B. QUAD CITIES UNIT 2 CYCLE 10 LICENSE

TECHNICAL SPECIFICATION CHANGES

Technical Specification pages: 1.1/2.1-1
1.1/2.1-4
1.1/2.1-7
Fig. 2.1-3
3.2/4.2-14
3.2/4.2-14a
3.3/4.3-5
3.5/4.5-5
3.5/4.5-10
3.5/4.5-12
3.5/4.5-14
3.5/3.5-14a
3.5/3.5-14b
Fig. 3.5-1 Sheet 1
Fig. 3.5-1 Sheet 2
Fig. 3.5-1 Sheet 3
Fig. 3.5-1 Sheet 4
Fig. 3.5-1 Sheet 5
Fig. 3.5-2
3.6/4.6-5a
3.6/4.6-13a

FIGURE 2.1-3
(SCHEMATIC)

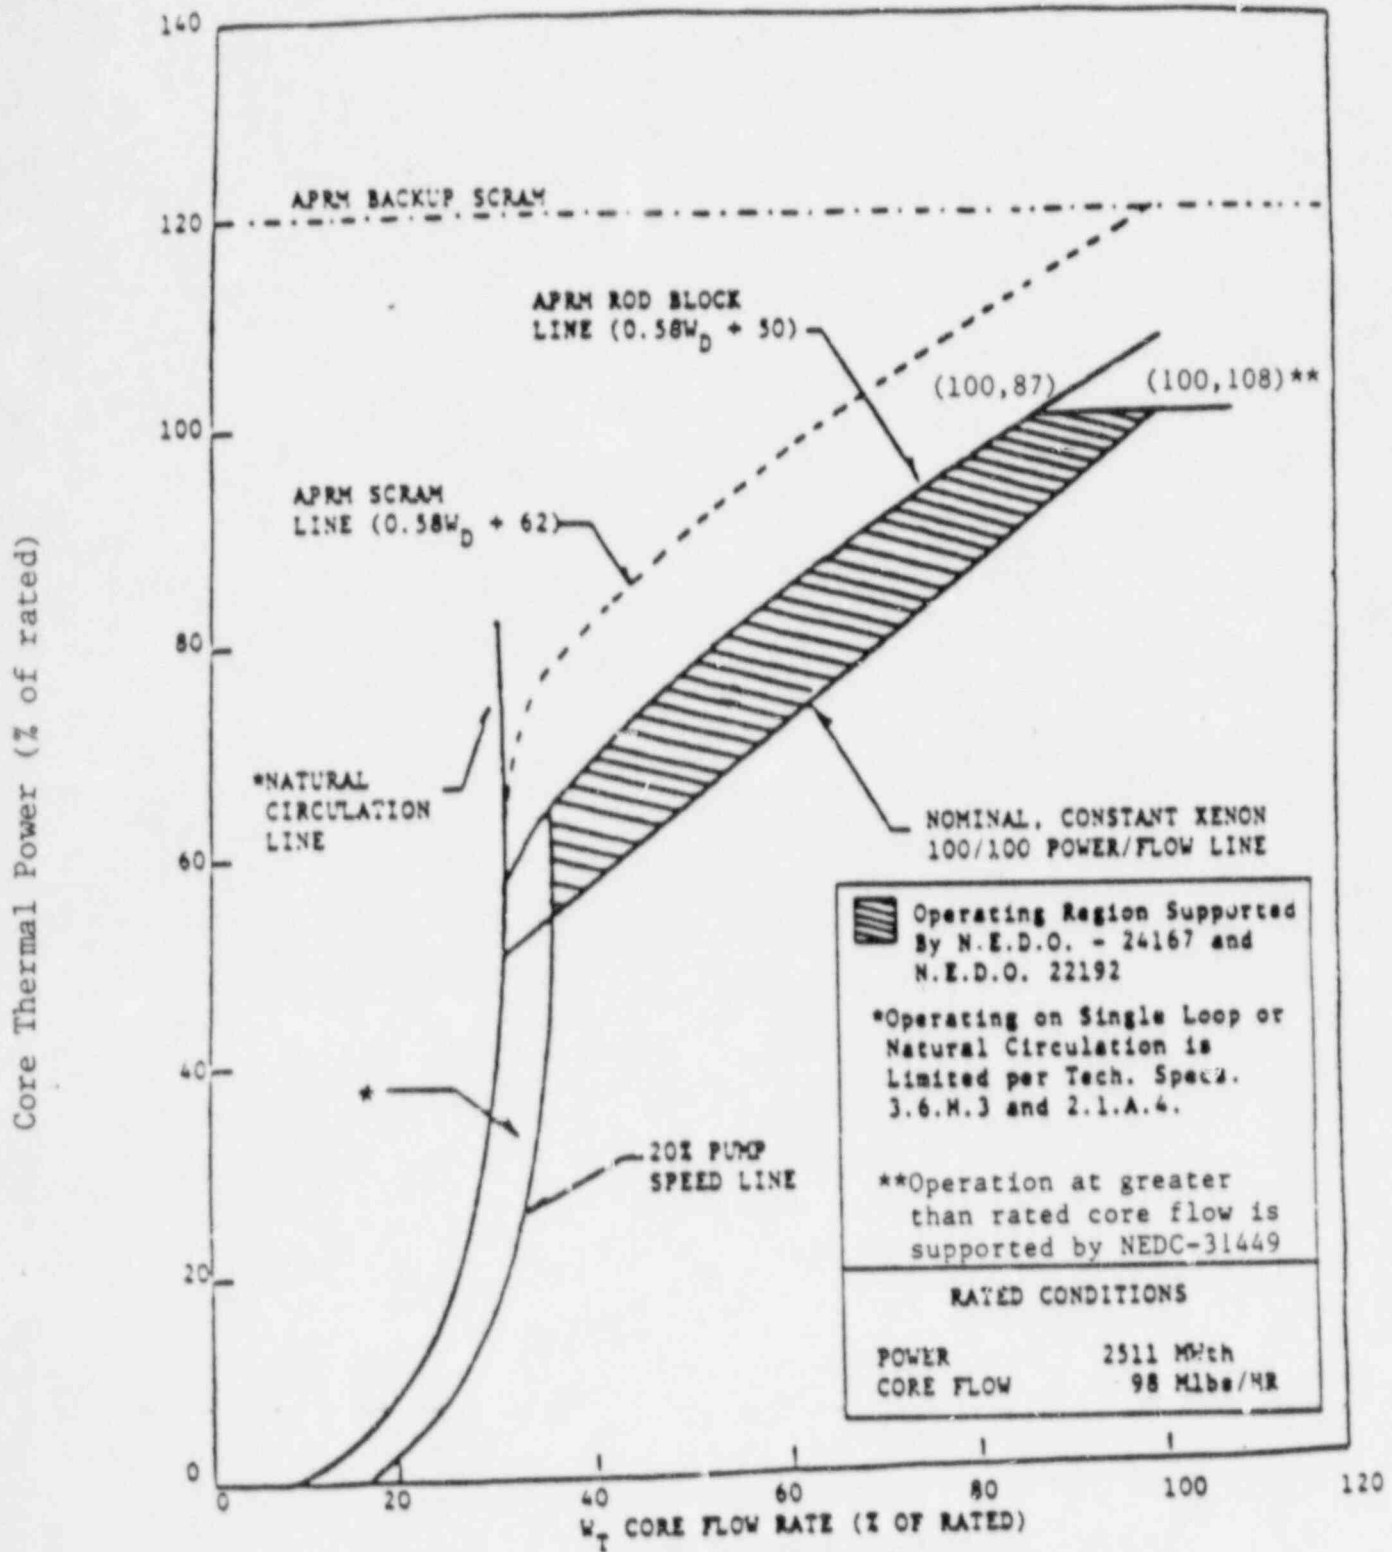
Onset of transition boiling results in a decrease in heat transfer from the cladding and therefore elevated cladding temperature and the possibility of cladding failure. However, the existence of critical power, or boiling transition is not a directly observable parameter in an operating reactor. Therefore, the margin to boiling transition is calculated from plant operating parameters such as core power, core flow, feedwater temperature, and core power distribution. The margin for each fuel assembly is characterized by the critical power ratio (CPR), which is the ratio for the bundle power which would produce onset of transition boiling divided by the actual bundle power. The minimum value of this ratio for any bundle in the core is the minimum critical power ratio (MCPR). It is assumed that the plant operation is controlled to the nominal protective setpoints via the instrumented variables (Figure 2.1-3).

Figure 3.5-1
Sheet 5 of 5

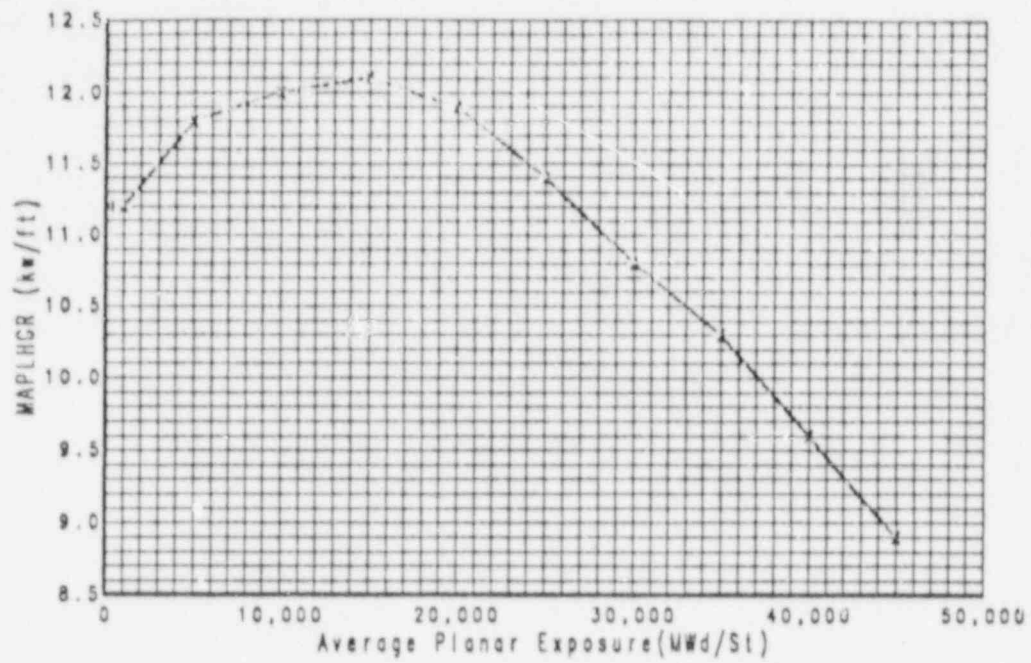
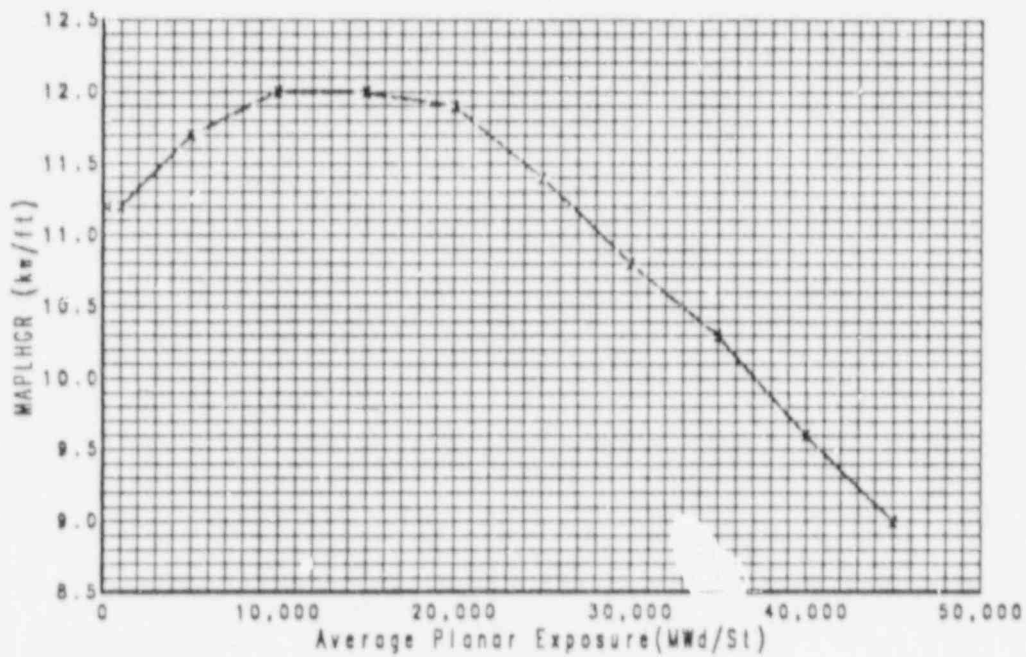
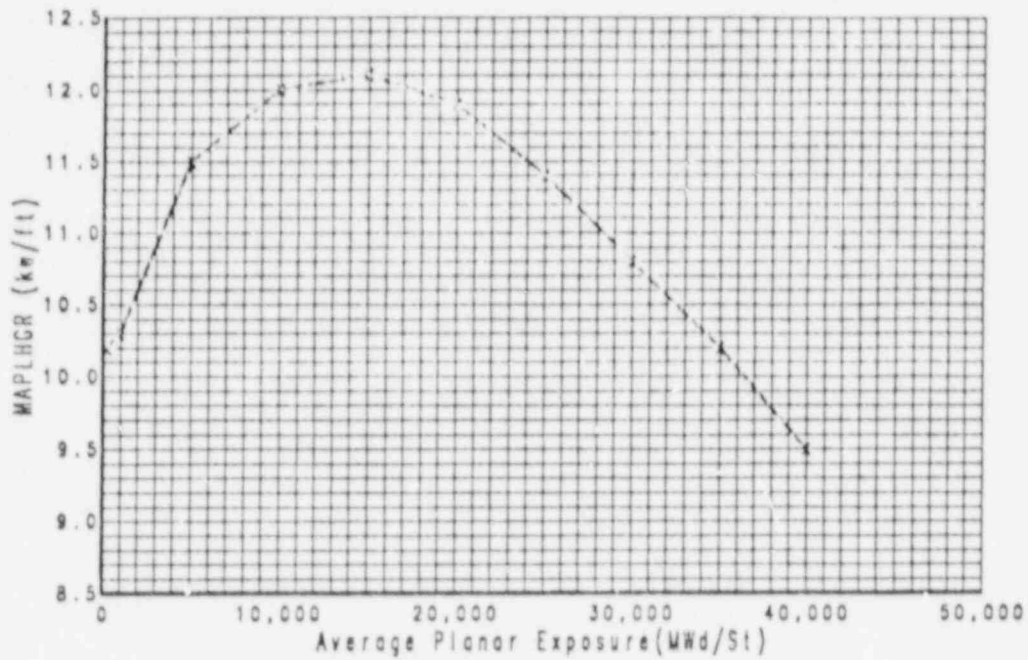
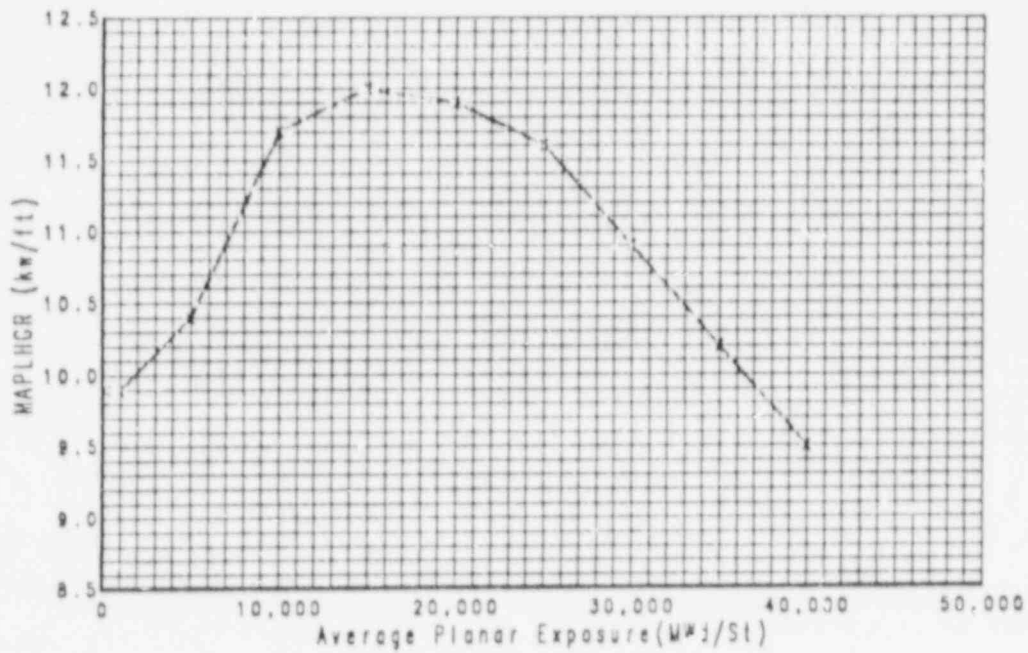
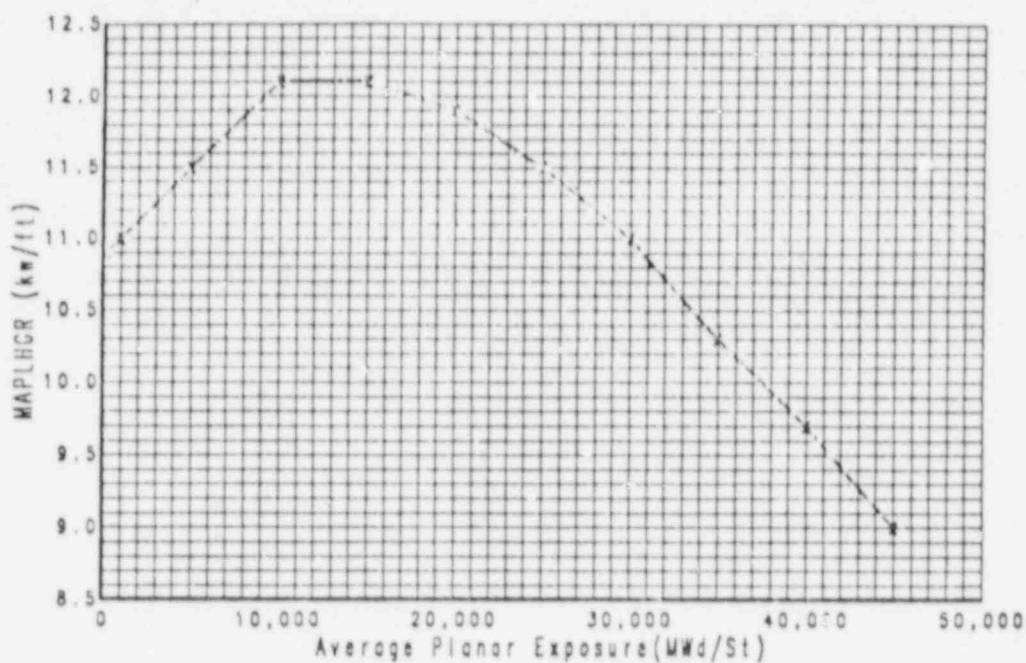
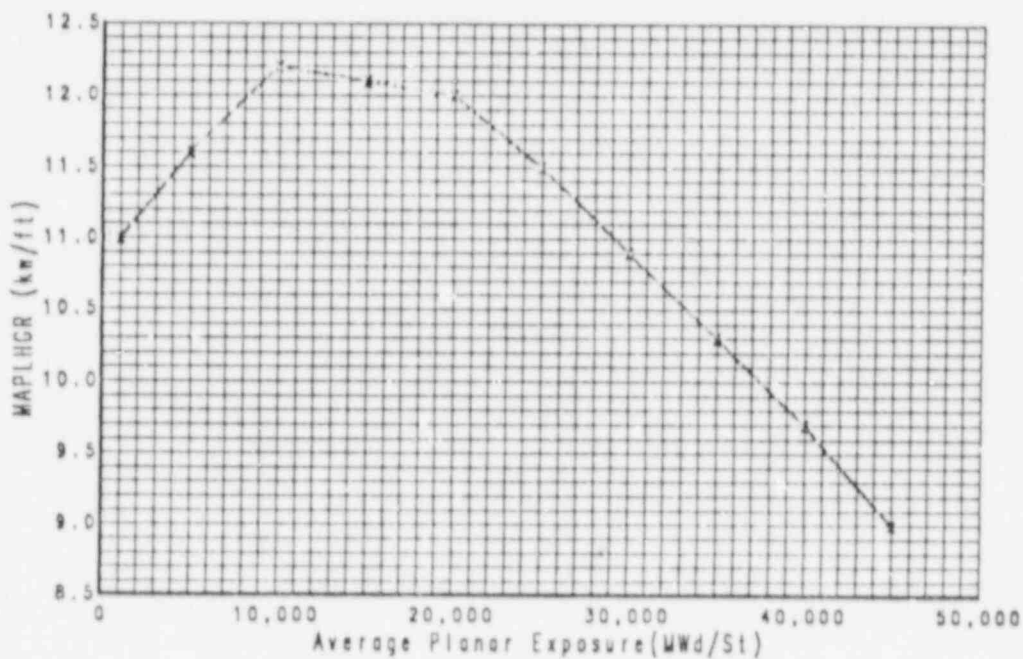
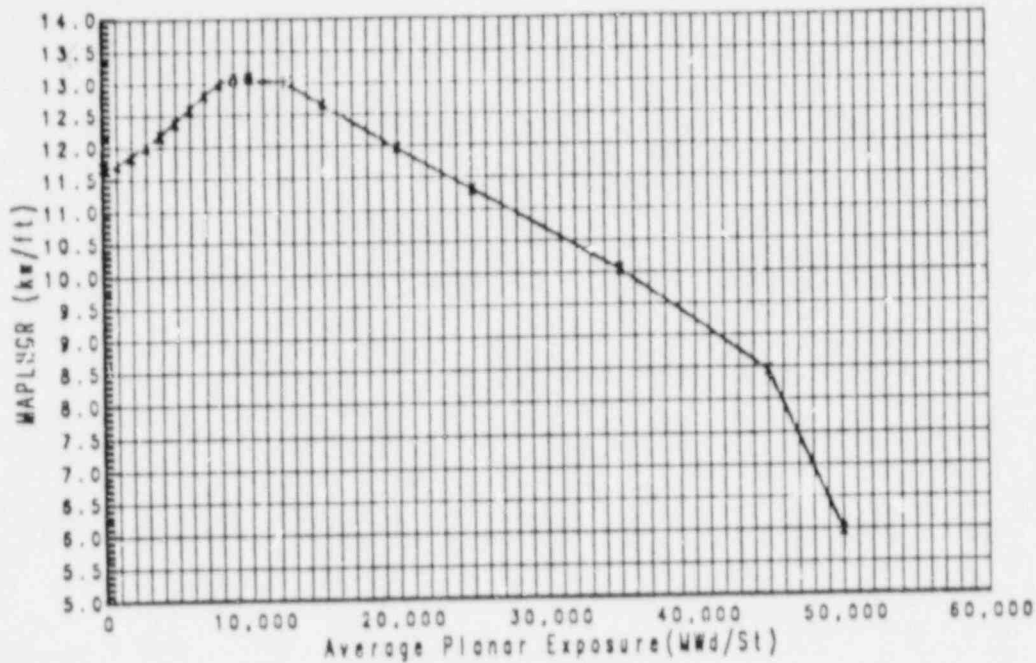
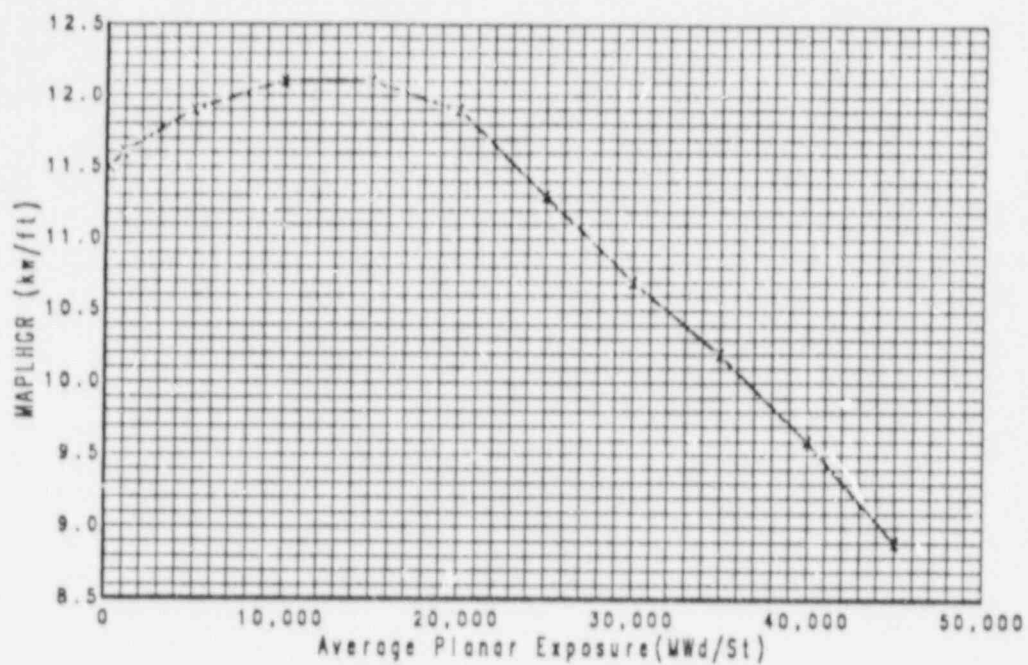
shown on Figure 3.5-1 as limits because conformance calculations have not been performed to justify operation at LHGR's in excess of those shown.

FIGURE 3.5-2

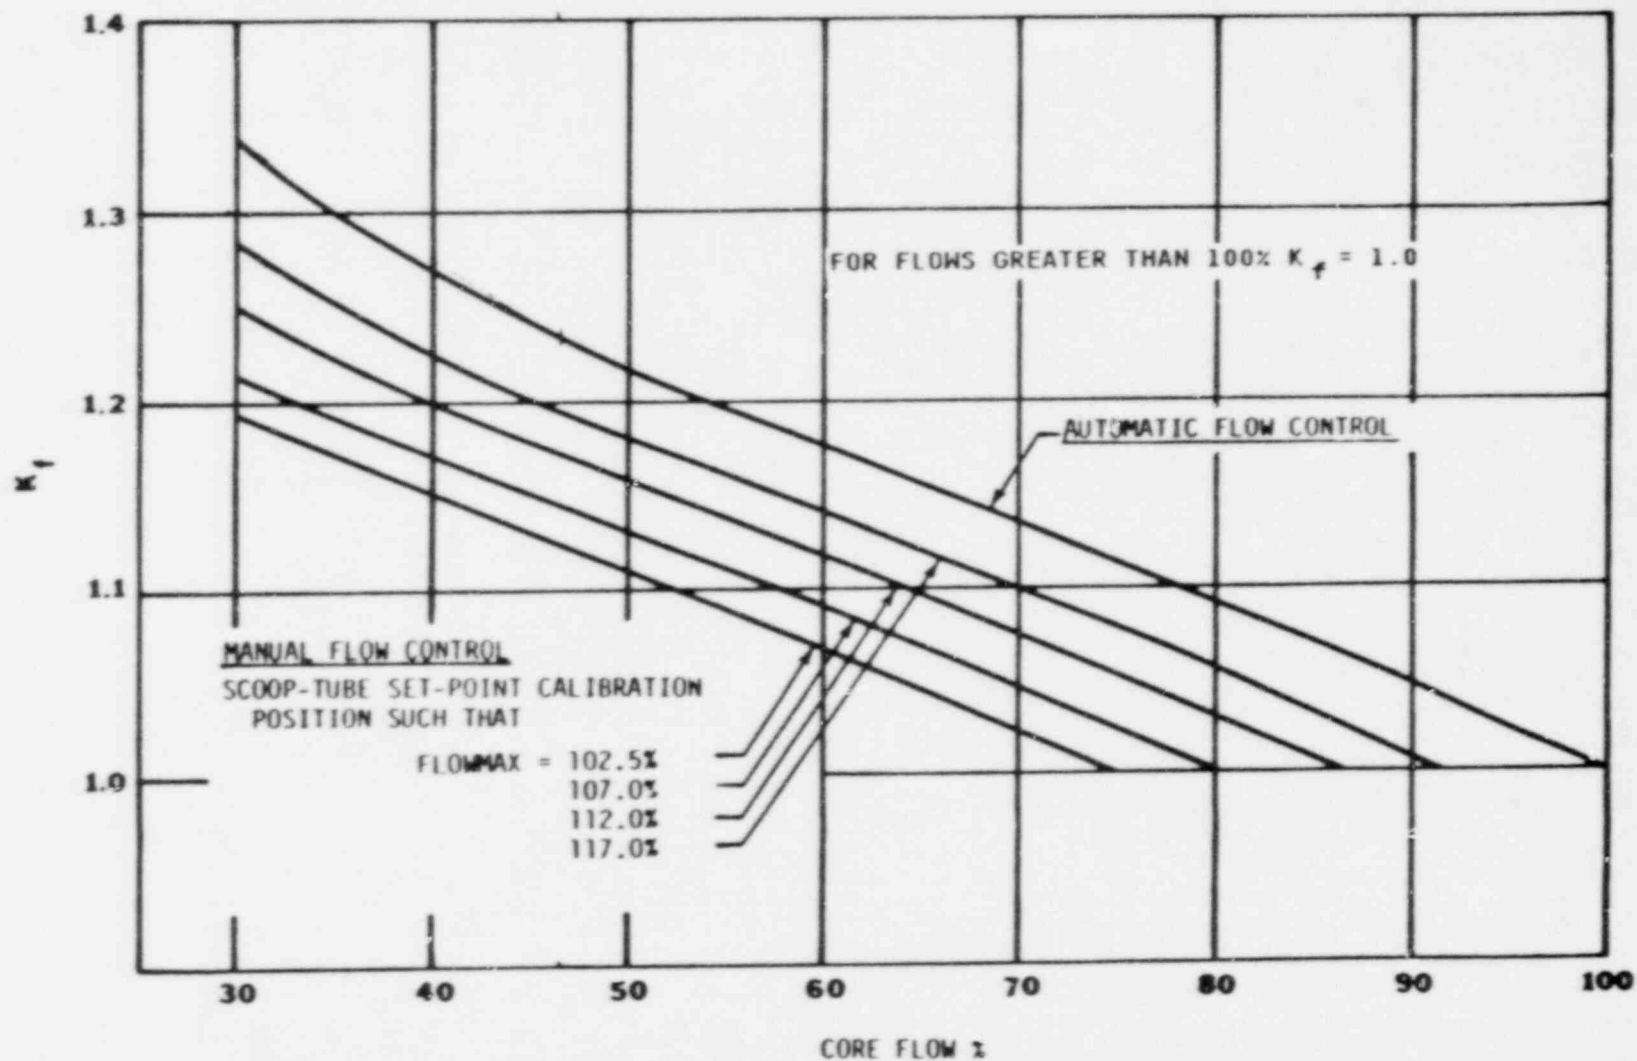
For core flows other than rated, these nominal values of MCPR shall be increased by a factor of k_f where k_f is as shown in Figure 3.5.2. If any time during operation it is determined by normal surveillance that the limiting value for MCPR is being exceeded, action shall be initiated within 15 minutes to restore operation to within the prescribed limits. If the steady-state MCPR is not returned to within the prescribed limits within 2 hours, the reactor shall be brought to the cold shutdown condition within 36 hours. Surveillance and corresponding action shall continue until reactor operation is within the prescribed limits.
